Rebuttal of NYC MTA Platform Screen Door Feasibility study

Author: Joe Wu, PhD

Figure 1 – Non-compliant ADA condition
72nd Street Station

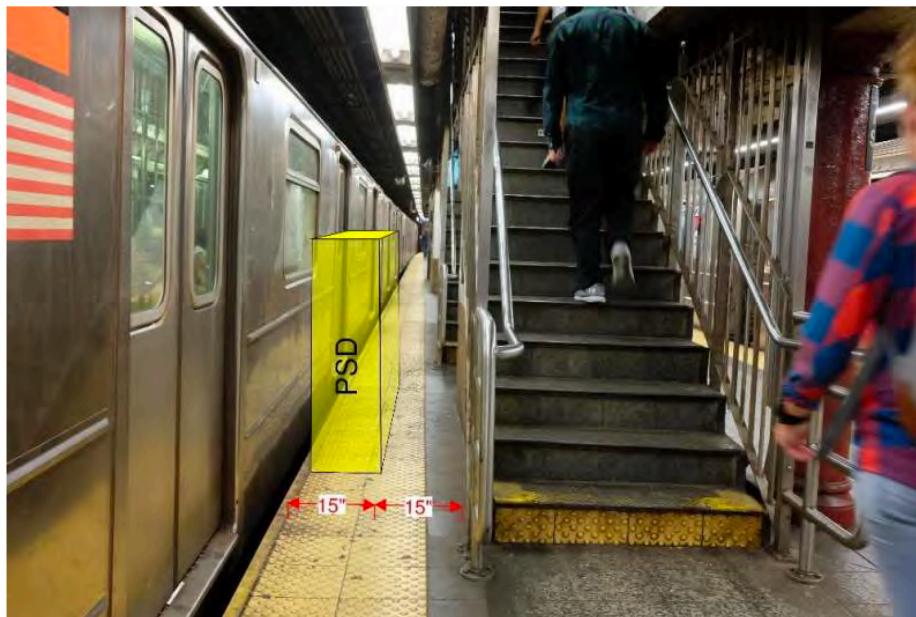
- They cite 36 inches the minimum ADA requirement.
- At 30 inches (15+15) this section of the platform was not compliant with ADA in the first place and is too narrow for passenger traffic regardless of disability status. One foot will touch the yellow no-step line if someone were to walk through that strip of the platform, which goes against MTA's public safety announcement.
- A person in a wheel chair will not be descending to the platform using the stairs.
